In the Drawings

Applicants propose amending the drawings as indicated on the attached replacement sheets and the annotated sheets.

Inventor: School et al. (as amended)
Docket No.: 177USI1
Title: BLOCK SPLITTING ASSEMBLY AND METHOD
Serial No.: 09/691,864
Sheet 1 of 6

F ig. 5

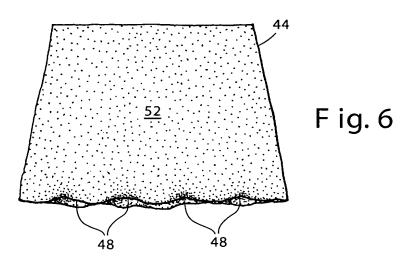
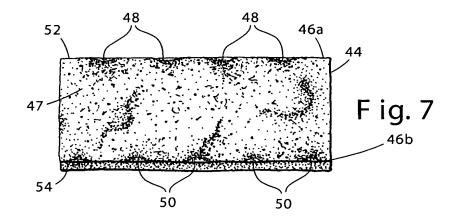
A) In Figure 5:

- i) Reference numeral 46 is removed.
- ii) Reference numerals 46a, 46b, and 46b' are added.
- iii) Reference numeral 46' has been changed to numeral 46a'.

In the original disclosure, reference numeral 46 was used to reference both the split edge of the block 42 and the front surface of the block (see page 6, lines 27-28 and page 7, lines 12-16). Further, in Figure 5, the lead line for numeral 46 points to the front surface of the block 44, rather than pointing to the block 42. Therefore, reference numeral 46 was used inconsistently and on different features.

The amendments to Figure 5 provide consistent use of reference numeral 46. The result of these changes is that the split edges of both blocks 42, 44, previously identified with reference numerals 46 and 46', are now referenced using numerals 46a, 46b, 46a' and 46b'. The changes are supported by the original disclosure, for example page 6, lines 27-28.

FIG.8

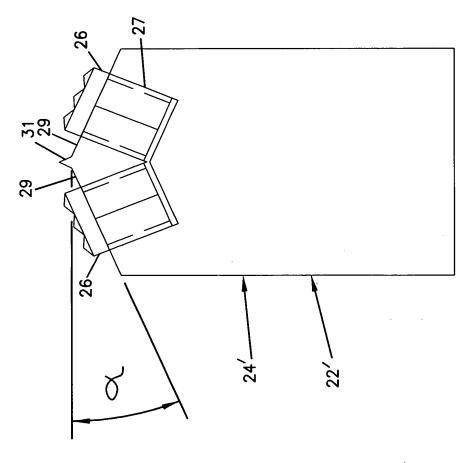
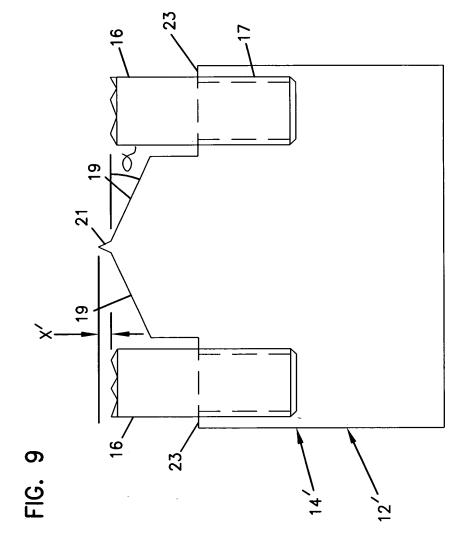
- C) i) In Figure 8, reference numerals 22 and 24 are changed to numerals 22' and 24' respectively.
 - ii) In Figure 9, reference numerals 12 and 14 are changed to numerals 12' and 14' respectively.
 - iii) In Figure 10, reference numerals 12 and 14 are changed to numerals 12' and 14' respectively, for consistency with the change made to Figure 9.
 - iv) In Figure 11, reference numerals 12 and 14 are changed to numerals 12' and 14' respectively, for consistency with the change made to Figure 9.

Likewise, reference numerals 22 and 24 were used to reference a splitting assembly and blade, respectively, in Figure 1. These same reference numerals were also used to reference the splitting assembly and blade, respectively, in Figure 8. However, the splitting assembly in Figure 1 is different than the splitting assembly in Figure 8.

Therefore, reference numerals 12, 14, 22, and 24 in Figures 8-11 have been changed to 12', 14', 22', and 24', respectively, to help clarify that the splitting assemblies and blades in Figures 8-11 are not the same as the splitting assemblies shown in Figure 1. As these changes involve altering reference numerals, and it is evident from Figures 1 and 8-11 that the splitting assemblies are different, the changes are supported by the original disclosure.
